## PUBLIC COMMENT ON PUGET SOUND ENERGY 2015 INTEGRATED RESOURCE PLAN, DOCKETS UG-141169 AND UE-141170

Response by James Adcock

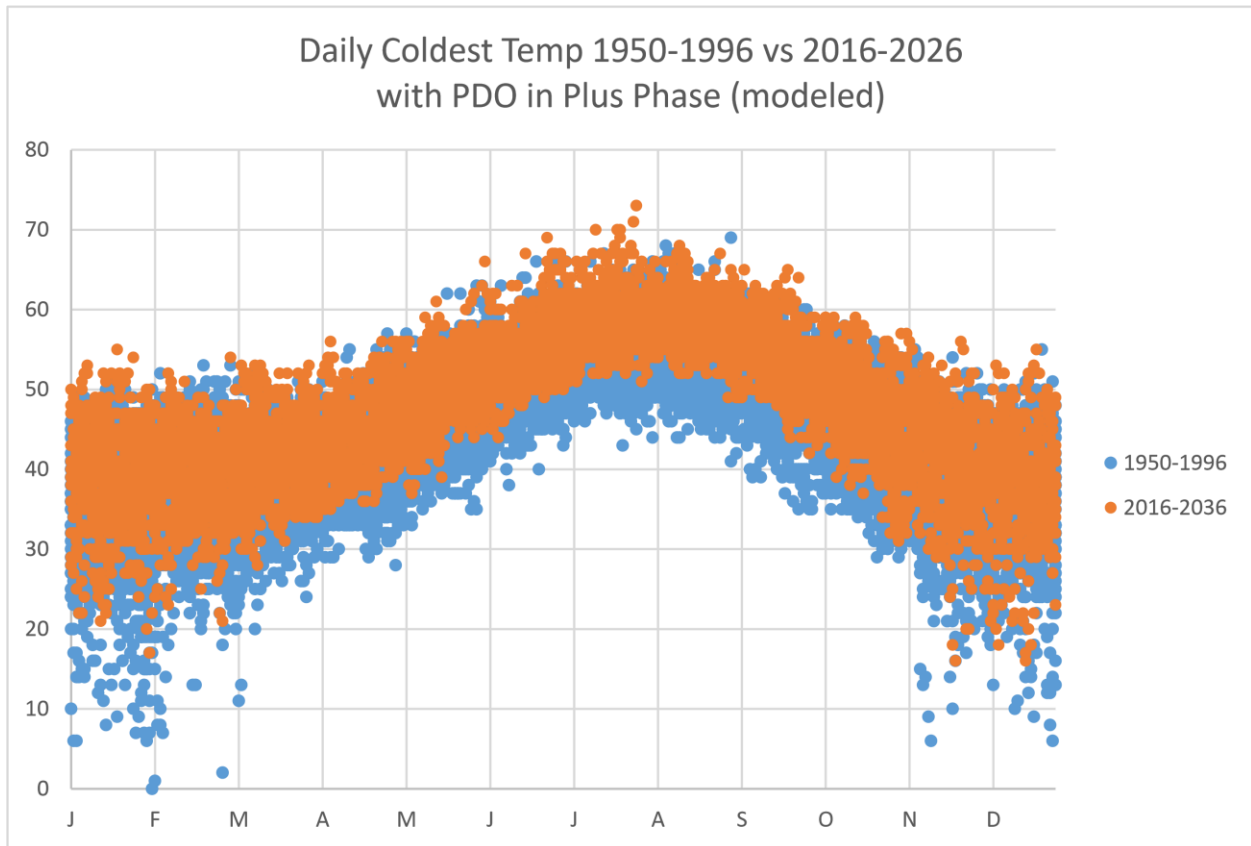
The below plot shows one dot per day for the coldest daily temperatures from the 1950s to date – about 24,000 data points. This is using NOAA SEATAC measurements as the reference temperatures – the same as PSE uses. Note the blue dots below (say) 10 degrees F during the winter months. Those coldest days all happened many many decades ago, 60+ years ago, when the climate was much less mild. In recent decades the coldest days have not gone below 13 degrees F – about a 25% reduction in heating load (HDD – Heating Degree Day, typically taken as outside temperatures measured below 65 degrees F)

When PSE designs their systems based on their new excessive “Once in 100 Years” criteria, what they are saying is that they are designing a system which would have not lost load even once in the 80+ year past record of coldest temperatures, temperatures going down to 0 degrees F (32 degrees below freezing) – ignoring the fact that coldest winter days (below 15 deg. F) have become much much warmer during that time frame. In the above plot the dots correspond to NOAA recorded lowest daily temperatures at SEATAC [the same location PSE uses for it calls its “Weather Modeling” [actually: “Climate Modeling” – you cannot model “Weather” 20+ years in advance.]

Plot of Daily Coldest Temperatures with an additional (conservatively modeled) +2 degrees F in future temperatures due to PDO shifting to its Warm Phase.

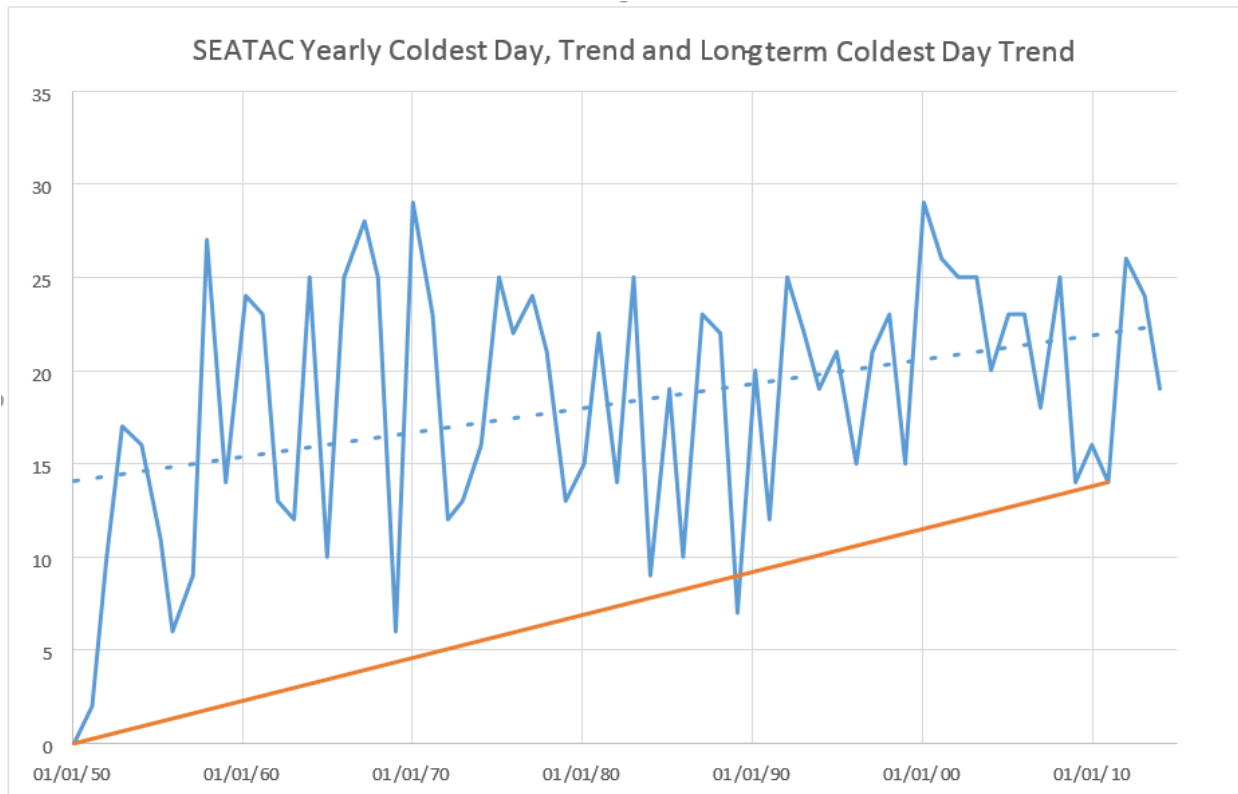
Now in addition, recently the PNW has experienced a change in the phase of PDO – the Pacific Decadal Oscillation. The PDO has shifted from its cold phase to its warm phase, further warming the PNW by several degrees F for the next 20-30 years – the lifetime of PSE’s proposed additional new NG Generating Plant. Below Plot of Climate Change includes a (modeled) conservative estimate of additional warming corresponding to the recent change of phase of the PDO – Pacific Decadal Oscillation – from its cold phase to its warm phase, further warming the PNW for the next 20-30 years – during that lifetime of PSE’s proposed new NG Peaker Plant.

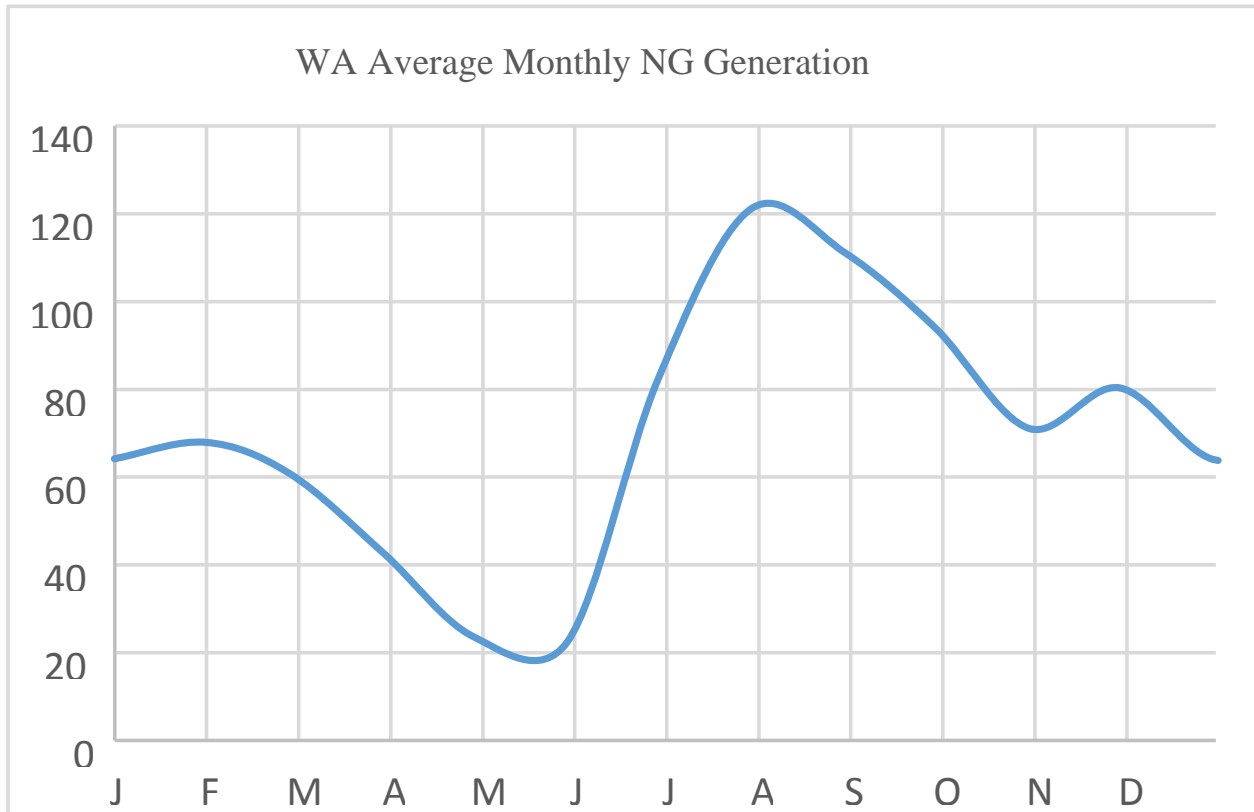
summer load. Below find a plot based on EIA data of WA average monthly NG generation, showing 2X as much NG Power is generated in August as compared to during Winter Months:

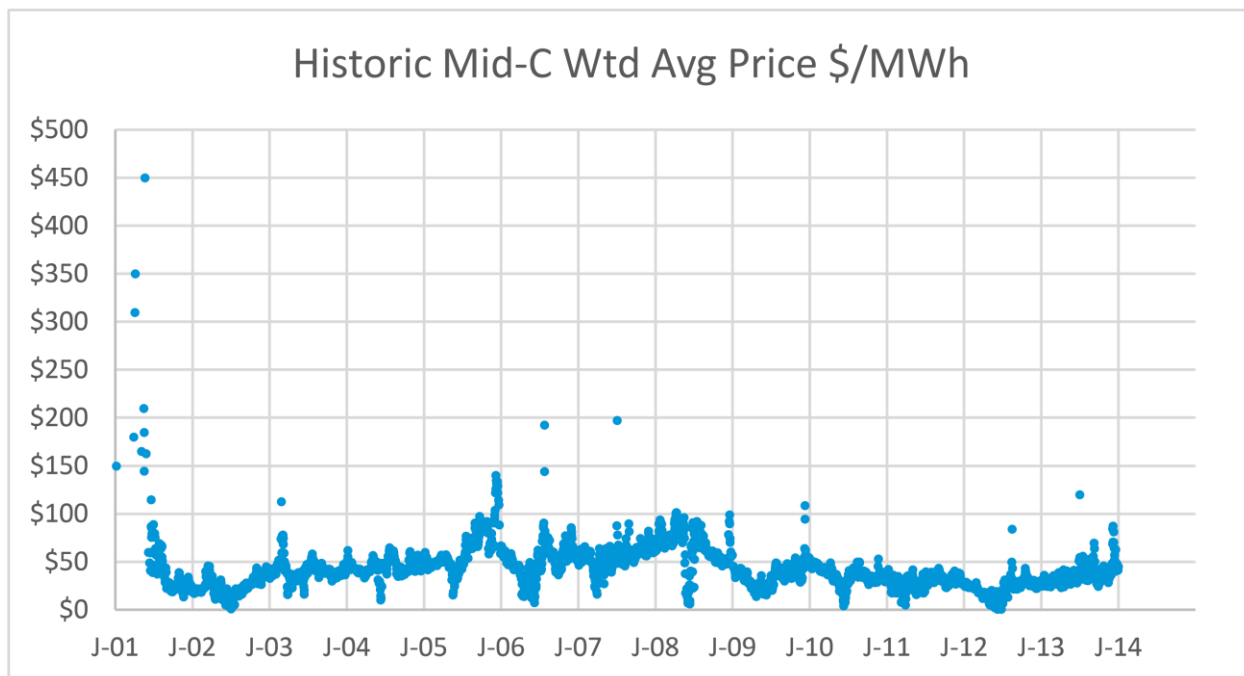
Please find attached two plots of Mid-C prices which demonstrate, contrary to PSE claims, that a new NG Peaker plant is NOT needed for Winter Peaking Needs. PSE acknowledges that they essentially “dispatch to market”, meaning based on Mid-C prices. If there was a shortage of Winter Peak Power then, Mid-C prices would jump much higher on those cold winter days. And, historically, as shown on the long-term historical plot, there have been such winter days – extremely rarely – prior to 2008. Since 2008 there have been rare high-priced Peak days – again, very rarely – but those have been Summer Peaking days, NOT Winter Peaking days. Conclusion: The region, and thereby PSE, net of BPA hydro power, is actually SUMMER peaking, not winter peaking as claimed by PSE. There is not a need for a new NG Peaker plant to meet winter peaking needs. Summer Peaking happens because in the summer we start to run out of BPA hydro power, we (the PNW) competes with California and regions south for power – AND because PSE mistakenly engages in a “PG&E Seasonal Exchange” contract where PSE sells power to PG&E during the summer when we are actually short of power, and buys power from PG&E when we are actually long on power [again, net of hydro] And there is no need for a Natural Gas Peaker during the summer, because these high-priced days happen so rarely that it is not nearly profitable to own a NG Peaker plant to cover those rare occurrences.

2015 Prices have been low and benign, trading recently around 2.5¢ / kWh (\$25 / mWh)– except briefly during the late summer period. This compares to about 36.2¢ / kWh (\$362 / MWh) for the levelized cost of NG Peaker Plants according to “The Levelized Cost of Electricity from Existing Generation Resources” June 2015, Institute for Energy Research. IE rational total cost of dispatch of an NG Peaker even during the rare peak summer days is still 3X too expensive to be useful. On a typical recent trading day prices have been about 14X too low to make owning an NG peaker plant a rational thing to do.

Historically Mid-C prices “blew up” in 2001, in the summer, not in the winter, as the California rational market for electricity collapsed, in part due to regulatory failures. "The California Electricity Crisis: Causes and Policy Options" 2003, Public Policy Institute of California. Thus, briefly, in 2001, a NG Peaker would have been “in the money” – it would have made sense to own a Peaker on those few days – if you could own a Peaker on just those few days. Since then prices have not come close to the \$362/MWh mark, even on a single day, let alone on average. Price spikes happen almost always during the summer, not the winter (a winter spike would happen near one of the above vertical grid marks, summer spikes fall in the middle between vertical grid marks.) Again, PNW, net of hydro, is Summer Peaking, NOT Winter Peaking.
